Final Supplemental Environmental Impact Report to the
Coleman Avenue/Autumn Street Improvement Project Final Focused
Environmental Impact Report (SCH# 2007042035) and the Downtown
Strategy 2040 Final Environmental Impact Report
(SCH# 2003042127)

Milligan Parking Lot Project

File No. ER20-049

April 2024

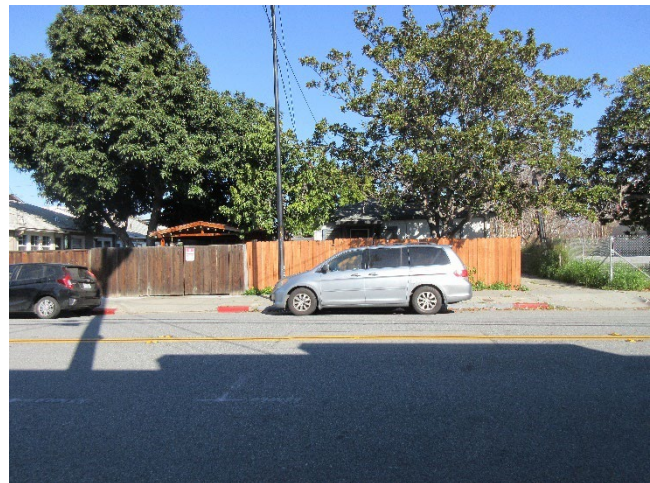
Comment A.6: 5. MM BIO-C-4.3 on page 65, under Off-site Mitigation it is noted that if adequate riparian habitat mitigation cannot be restored on-site, the riparian habitat will be enhanced or restored to native habitat along the immediately adjacent riparian corridor. As noted above, Valley Water's fee title property and easement are immediately adjacent to the project site. Valley Water does not allow mitigation for non-Valley Water projects on Valley Water property due to the significant mitigation needs of Valley Water. It should also be noted that all proposed plantings within Valley Water's easement are subject to review and approval by Valley Water.

Response A.6: Mitigation measure MM BIO-C-4.3 on page 65 of the Draft SEIR has been updated to note restoration/enhancement activities immediately adjacent to the riparian corridor (within the Valley Water's fee title property and easement) would require coordination with and approval by Valley Water (see Section 5.0 Draft SEIR). As noted, in Responses A.1 and A.4, the City has reviewed the project site's title reports and determined there are no Valley Water easements on the project site. The project would not require habitat restoration within the Valley Water easement adjacent to the project site as no work is proposed off-site. [This clarification to the mitigation does not change the conclusions of the Draft SEIR analysis.

For restoration/enhancement activities immediately adjacent to the riparian corridor (within the Valley Water’s fee title property and easement), the City shall coordinate with Valley Water for approval.
